The article addresses a relevant issue for a seismic country as Colombia; it gives relevant information about the seismic risk of the Sabana Centro providence. Nonetheless, there is no novelty on the article and key information is not given in the paper. Results from the selected scenarios indicate consequences of concern not well supported. My main concern regards the selected fragility curves: I find it complex to perform a risk analysis using fragility functions developed by different methodologies and as stated by the authors, with different limit states definitions. I believe this is one issue that requires additional explanation. For example, comparison between fragility functions is not presented. Do the set of curves behave as expected? Information given in Table 5 is not enough. The article should present figures that allows for a visually appreciation of the curves. A brief explanation of the methodologies uses for the curves' development should also be included, as well as an opinion about how reliable the curves are. How can the authors explain that the number of collapse buildings is almost three times the number of buildings with extensive damage? Furthermore, the num

Figure 1. Contribution of tectonic environments to the seismic hazard of the Sabana Centro municipalities

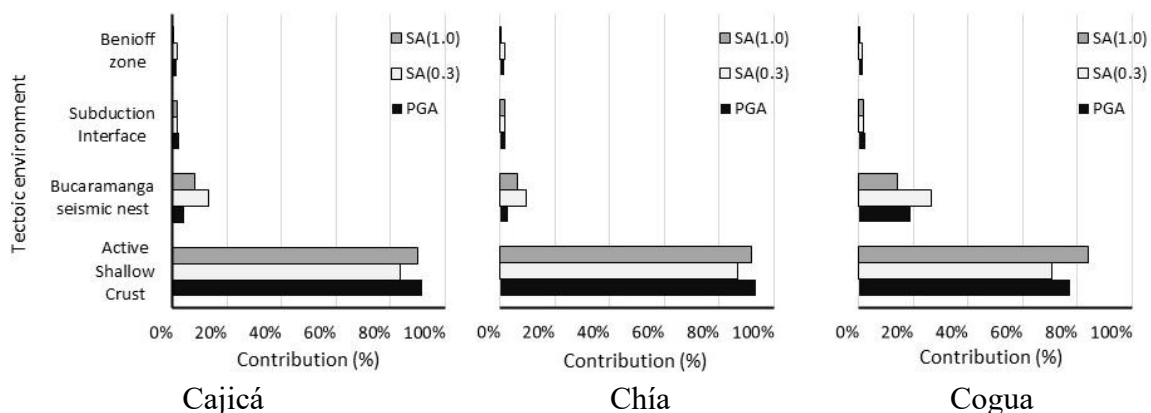
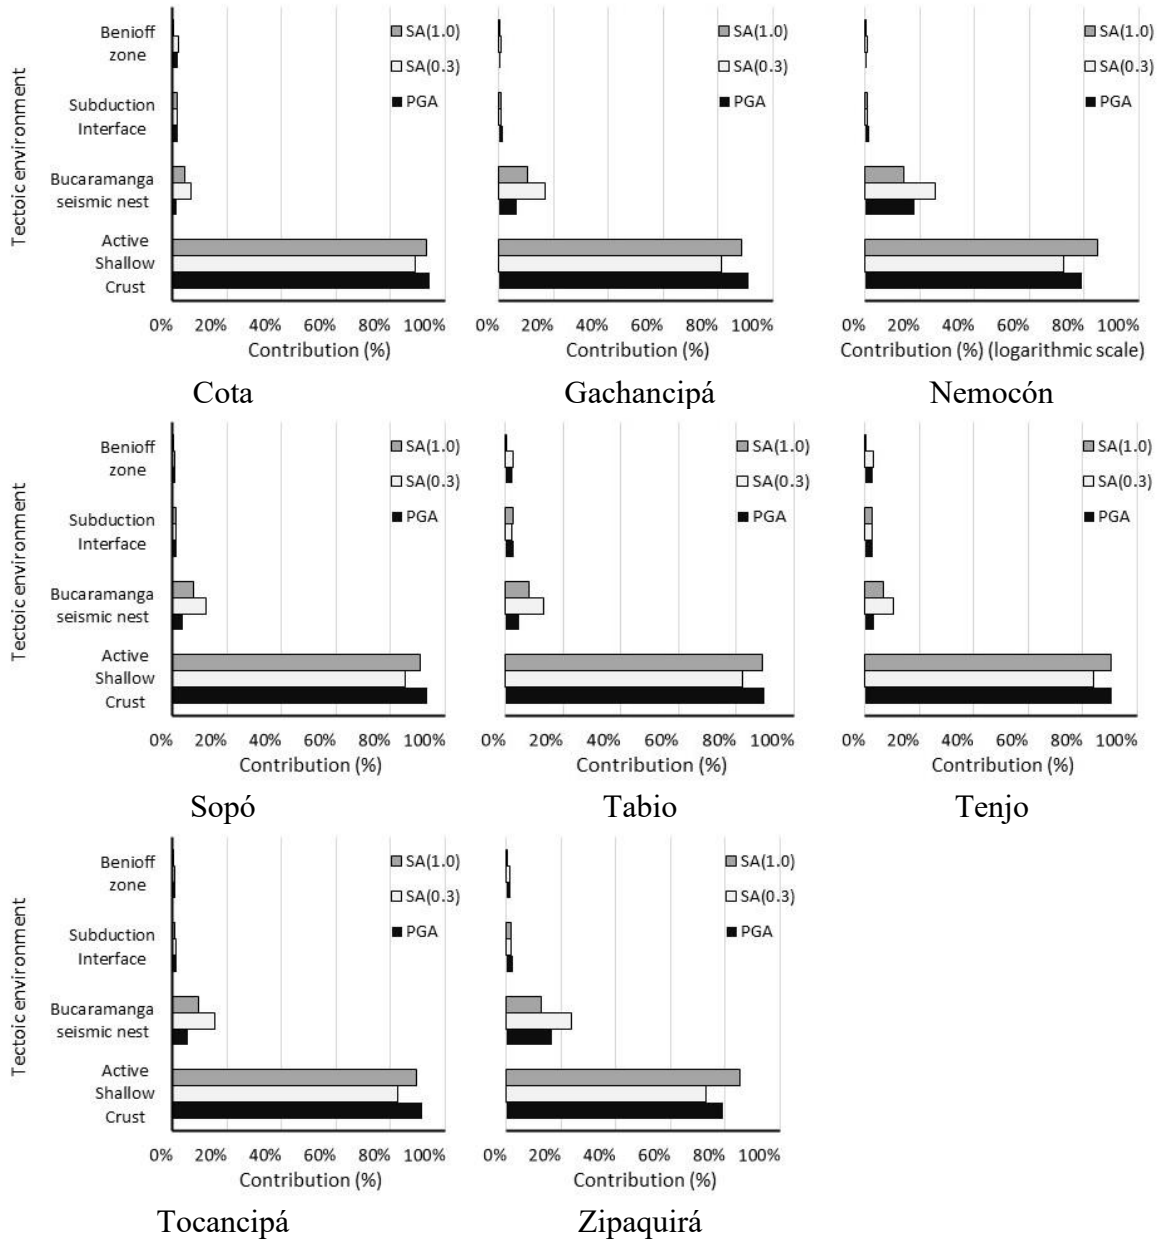
3. Why do all the scenarios are crustal shallow events? In the article it is mentioned that for SA (1.0s) there is an important contribution of subduction events. As the number of scenarios is important (18) some of them should be subduction events.

R/: We looked at the contributions by tectonic environments to the seismic hazard at the PGA Sa (0.3) and Sa(1.0s) In figure 1 it is possible to observe that the seismic hazard is controlled by active shallow crust events, being its contribution greater than the 75% in all the municipalities. Moreover, at the PGA it is greater than 90% for municipalities like Chía and Cajicá, where a significant number of one and two-story building concentrate. The contribution of the Bucaramanga seismic nest is more relevant in the municipalities at the north of the region in Cogua, Nemocón and Zipaquirá. In such cases, the contribution of the Bucaramanga seismic nest is around 25%. Based on this, we decided to keep the eighteen crustal scenarios and run one from the Bucaramanga seismic nest. We would like to point that the damage results for this scenario are low (collapses range between 0.1% and 0.2%).
